DEPARTMENT OF TRANSPORTATION

DEL-71-8.91 (PHASE A)

CONSTRUCT A NEW PARTIAL DIAMOND INTERCHANGE ON I-71 AT SUNBURY PARKWAY. THIS WILL INCLUDE AN ENTRANCE RAMP FROM SUNBURY PARKWAY TO I-71 SB AND AN EXIT RAMP FROM I-71 NB TO SUNBURY PARKWAY. BUILD A I-71 NB CD ROAD BETWEEN SUNBURY PARKWAY AND SR 36/37 COMBINING THE EXITING TRAFFIC TO SUNBURY WITH THE EXITING TRAFFIC TO SR 36/37. CONNECT SUNBURY PARKWAY TO WILSON RD. THE PROJECT WILL ALSO INCLUDE THE SUNBURY PARKWAY TWO SPAN BRIDGE OVER I-71, THE RECONSTRUCTION OF STORM SEWERS AND CULVERTS, AND THE RELOCATION OF SIGNAGE AND LIGHTING. THE FULL PARCLO INTERCHANGE AND THE EXTENSION OF SUNBURY PARKWAY WILL BE BUILT IN FUTURE PHASES.

DESIGN AGENCY  ms consultants, inc.	
DESIGNER ACW	
REVIEWER TAZ 06/29/23	
PROJECT ID 106959	
SHEET P.12	TOTAL 663

PLAN - SUNBURY PARKWAY
STA. 105+00.00 TO STA. 109+44.85

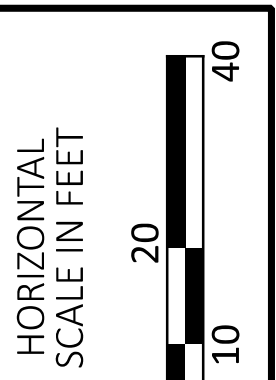
NO.	RFI	DESCRIPTION	REV. BY	DATE
PIR4	.	STORM REVISIONS	ACW	04/11/25

PLAN & PROFILE - WILSON ROAD
STA. 109+00.00 TO STA. 111+12.38

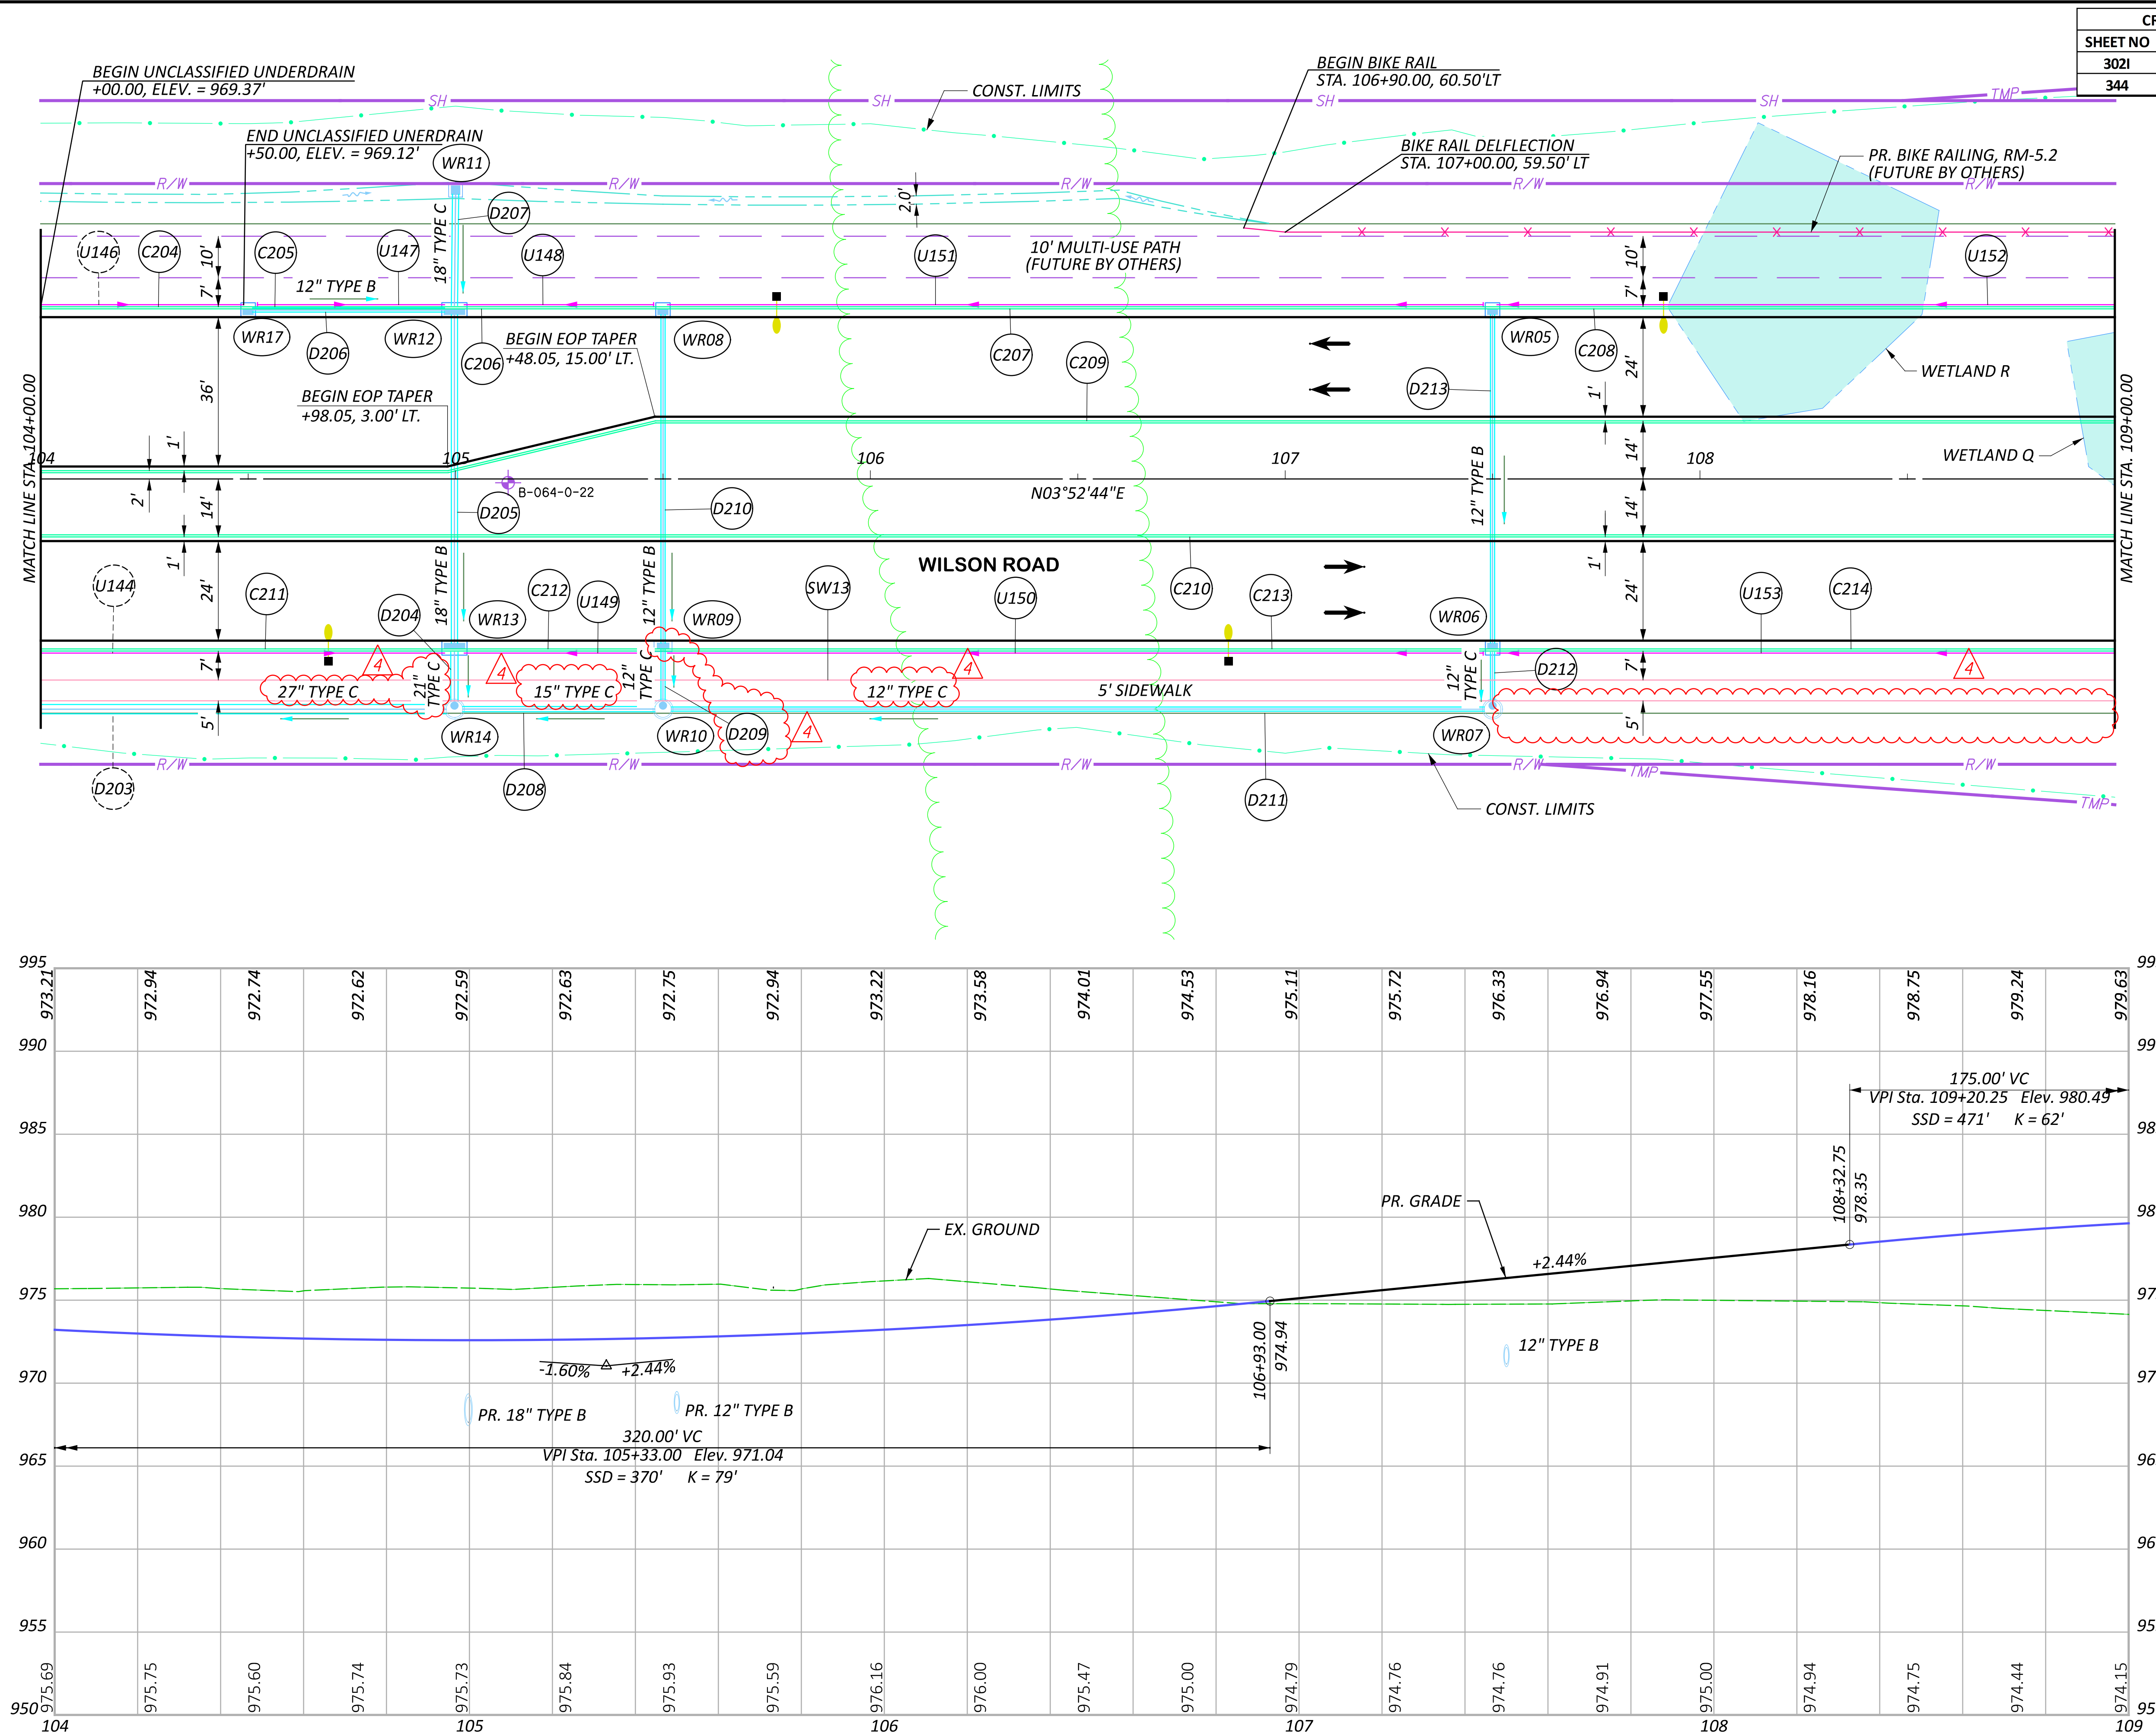
NO.	RFI	DESCRIPTION	REV. BY	DATE
PIR4	.	CONDUIT CHANGES	ACW	04/14/25

STORM PROFILES
SUNBURY PARKWAY

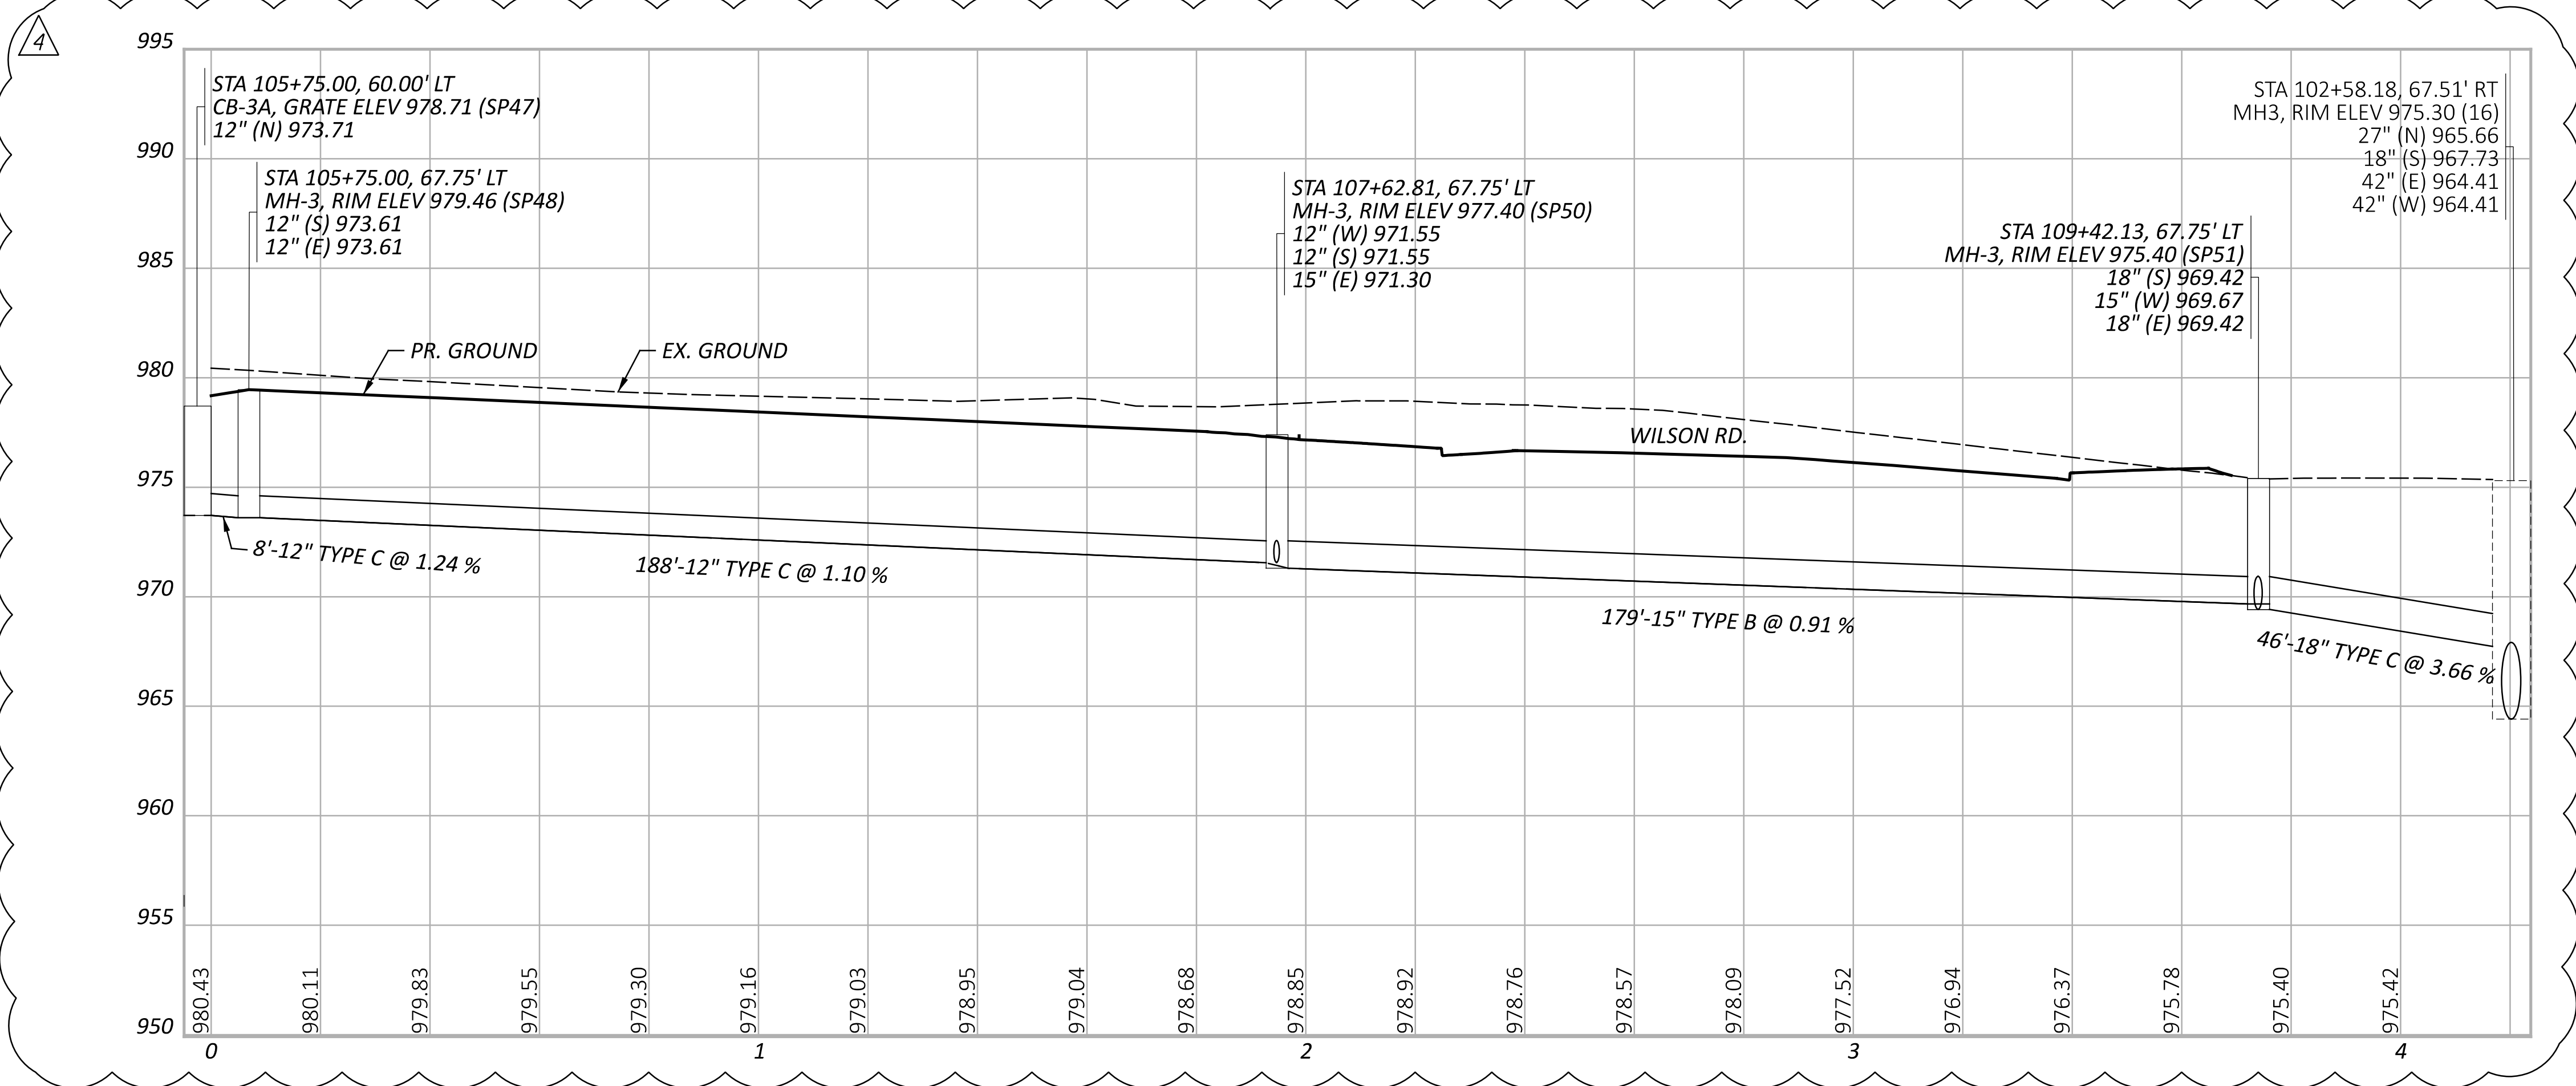
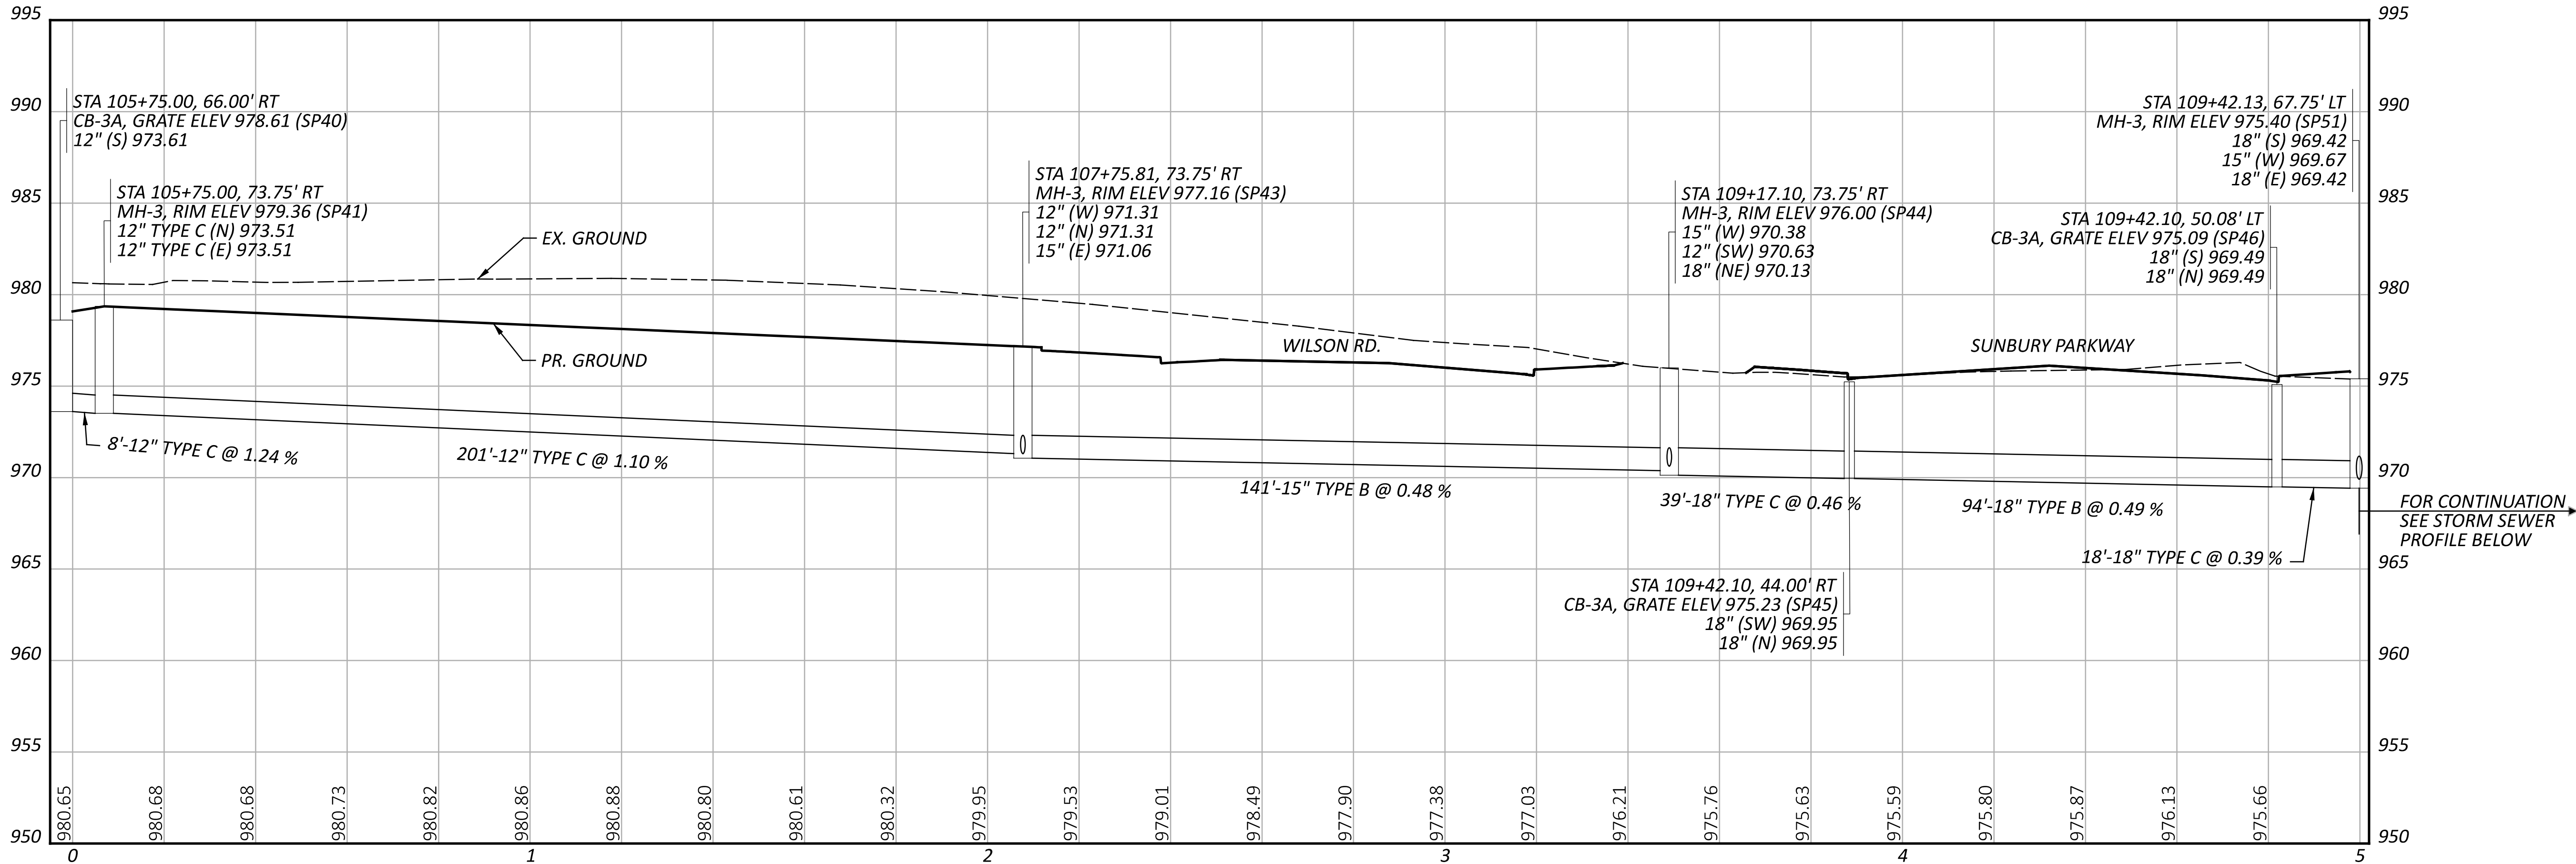
NO.	RFI	DESCRIPTION	REV. BY	DATE
PIR4	.	REVISE DRAINAGE PROF	CLH	4/09/25
.	.	.	.	.
